REV.
A

AS9528

SCREW, MACHINE STEEL UNS G87400,
CADMIUM PLATE, DRILLED, 1 HOLE,
HEXAGON HEAD, .1640-36 UNJF-3A

AS9528
SHEET 1 OF 2

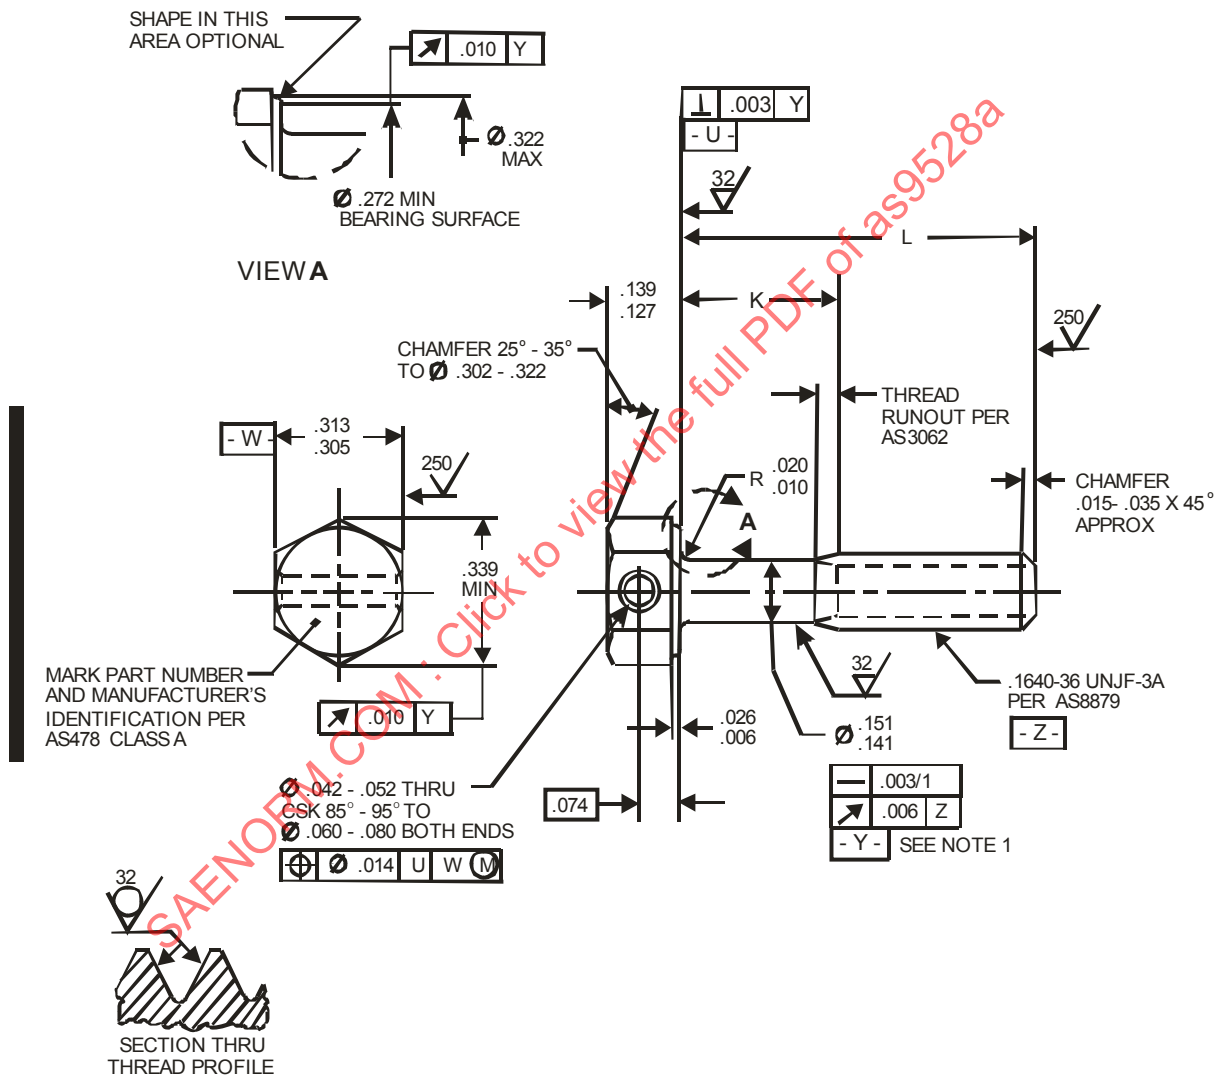
STANDARD UPDATED, CADMIUM WARNING NOTE ADDED, THREAD SPECIFICATION REVISED TO AS8879, AND GEOMETRIC CONTROLS FOR SHORT LENGTH SCREWS CLARIFIED TO AGREE WITH AS1132.
